# CREAMFIELDS

Statement of Response to An Bord Pleanála Opinion in  
respect of the proposed  
Creamfields SHD, Cork

Figure 1. Proposed new pedestrian crossings on the Mick Barry Road. (Credit: Arup, 2022).

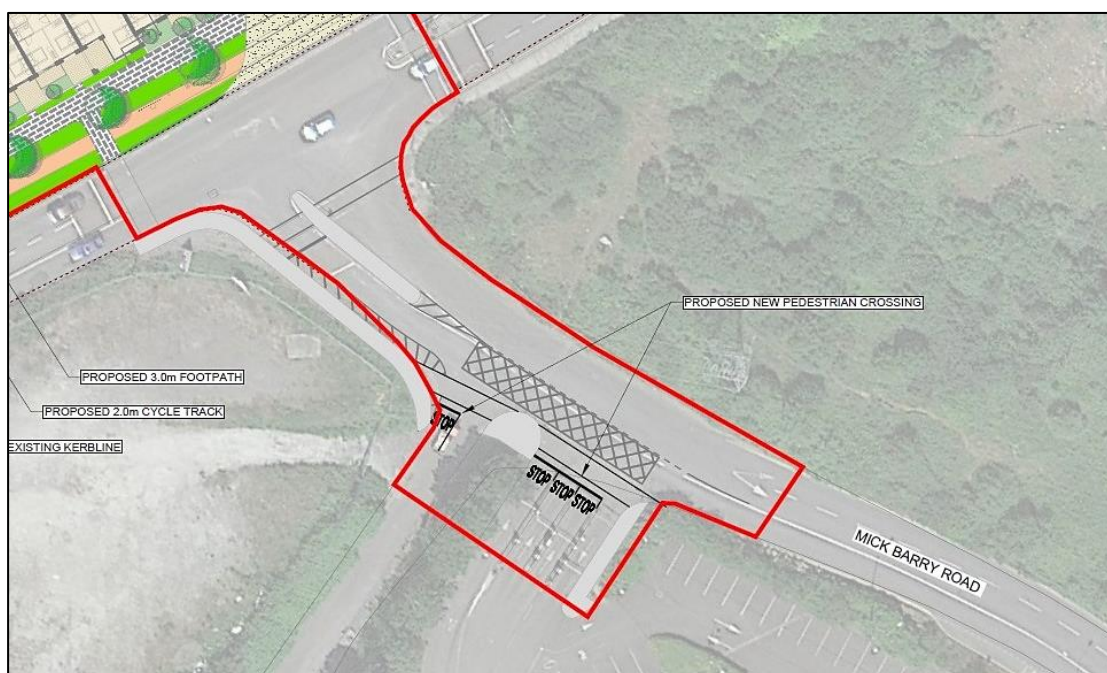
*Clarification at application stage as to the provision of pedestrian and cycle connectivity from the development site to the closest bus stop and Black Ash Park and Ride. Any impediments to such connections should be clearly identified and proposals submitted as to how such impediments are to be overcome.*

2.2.5 As part of this planning application, it is proposed to provide a formal pedestrian crossing across the commercial property access to provide pedestrian priority and to continue the pedestrian route up to the Park and Ride pedestrian access, which is located just east of the vehicular access.

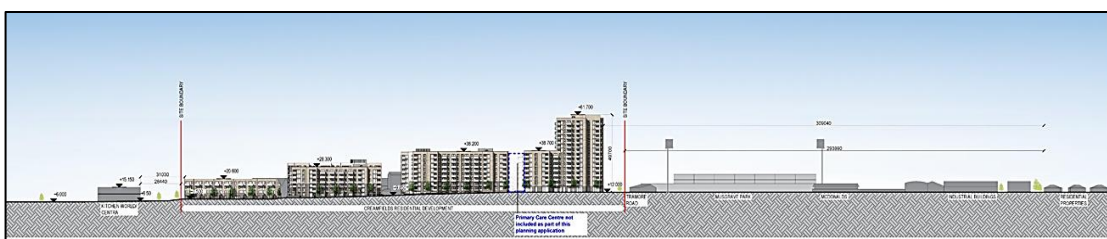
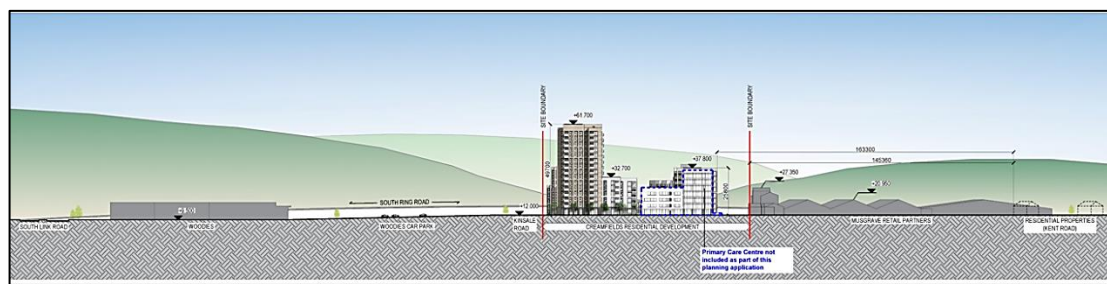
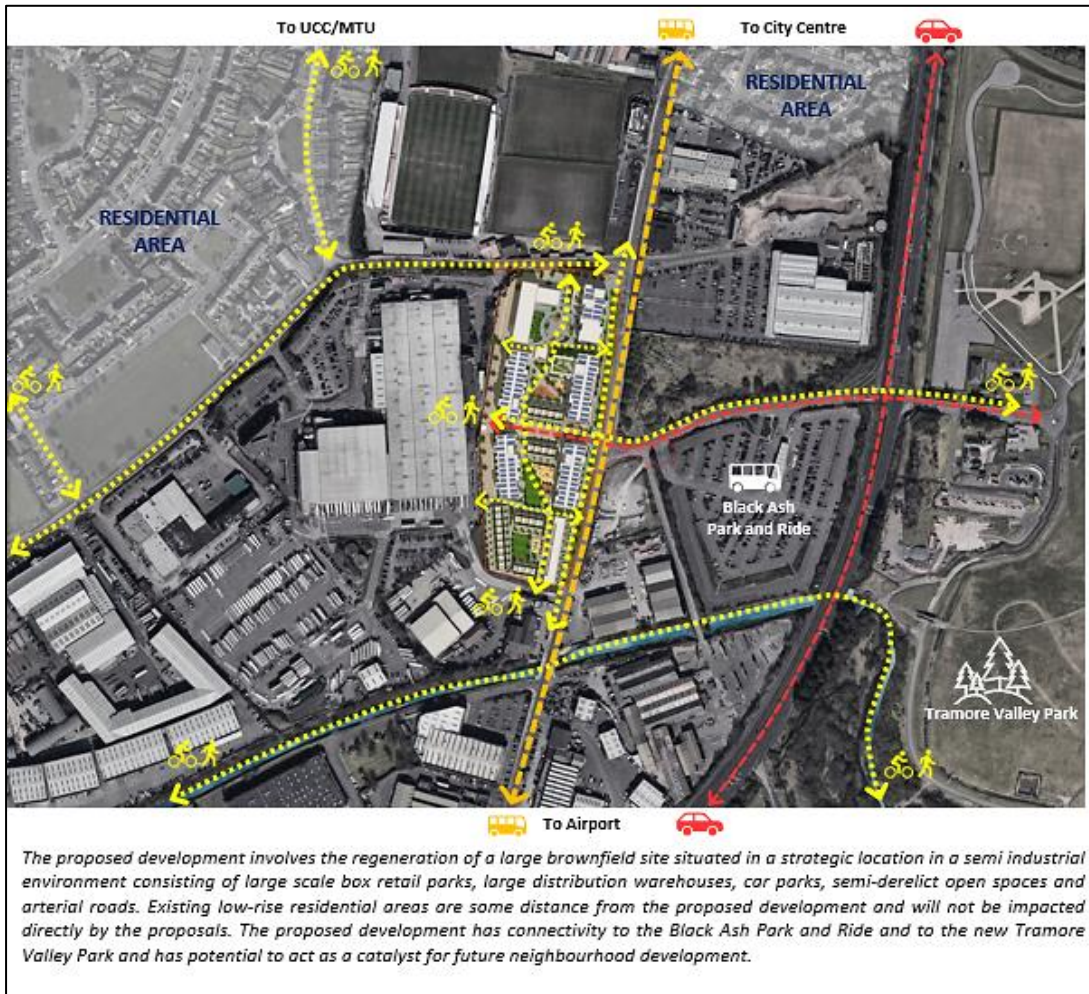
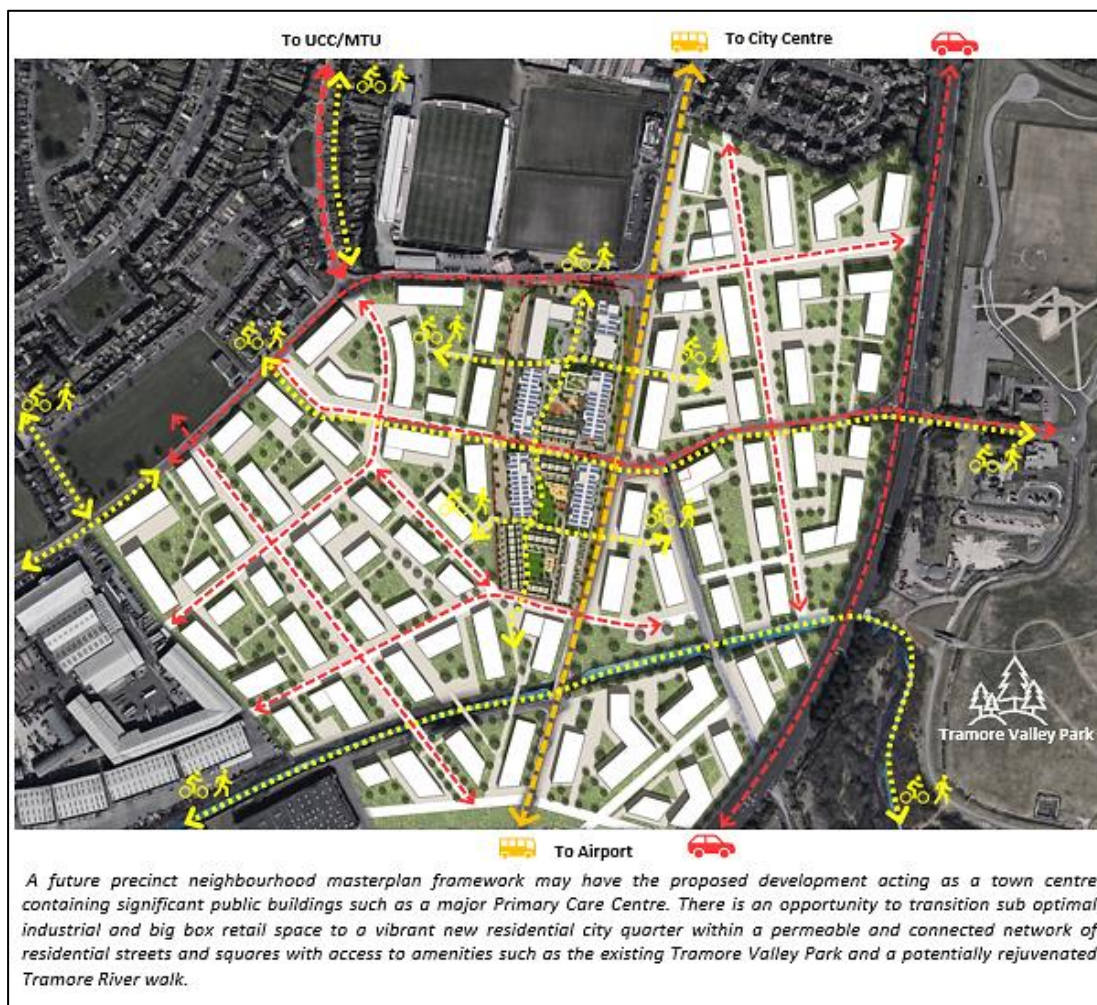
*Further justification for the height strategy, integration with the wider area and density, specifically how transition occurs in terms of design, presentation, quality community and place making. A key issue at this location is the existing environment and specifically how transition occurs between the existing established development and the proposed development cognisance being had that this development will form a catalyst for future development on surrounding lands.*

- 2.3.12 Figures 2, 3, 4 and 5 below outline the permeability and connectivity of the site along with its surrounding context.

Figure 6. Dual aspect apartment breakdown of part of the proposed development. (Credit: Reddy Architecture and Urbanism, 2022).

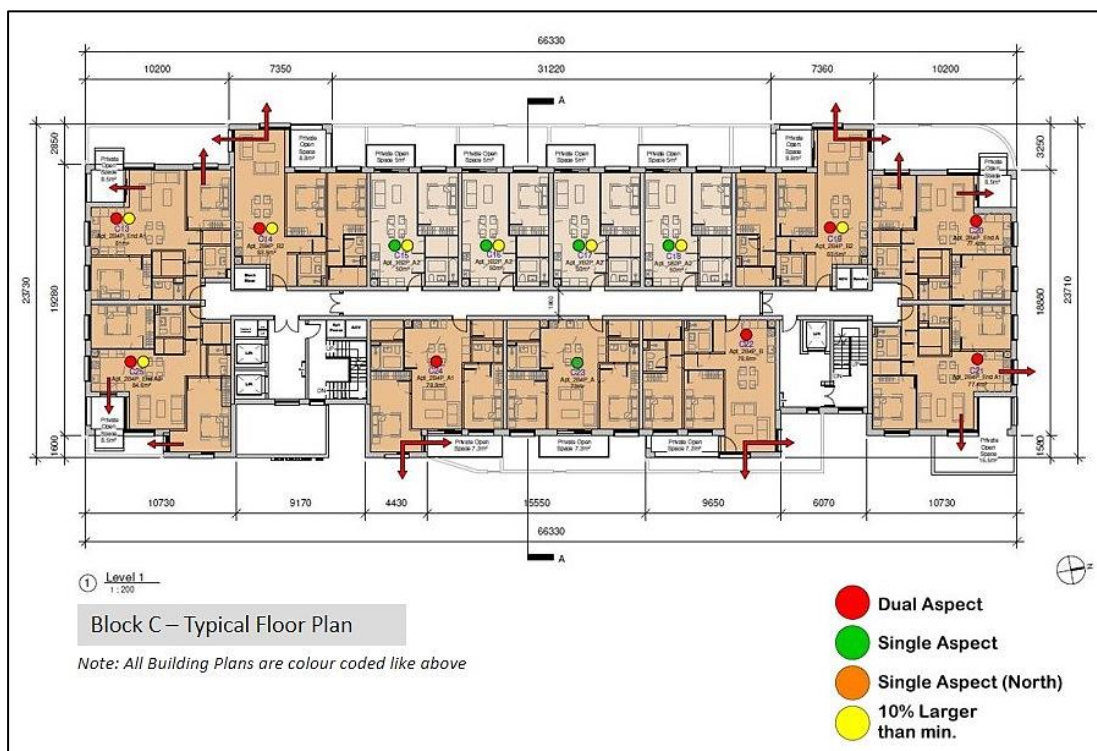
*This provides details in respect of the proposed apartments set out as a schedule of accommodation, with the calculations and tables required to demonstrate compliance with the various requirements of the 2020 Guidelines on Design Standards for New Apartments. It is important that the proposal meets and preferably exceeds the minimum standards in terms of dual aspect and proportion of apartments which exceed the floor area by 10%. In the interests of clarity clear delineation / colour coding of floor plans indicating which of the apartments are considered by the applicant as dual / single aspect, single aspect north facing and which apartments exceeds the floor area by 10%.*

2.6.3 As requested, Reddy Architecture and Urbanism have denoted which of the units are considered by Watfore Limited as dual/ single aspect, single aspect north facing, and which units exceed the floor area by 10% by the use of colour dots, as illustrated below. Arrows have also been used to demonstrate direction of view for further clarity regarding those units deemed to be dual aspect.
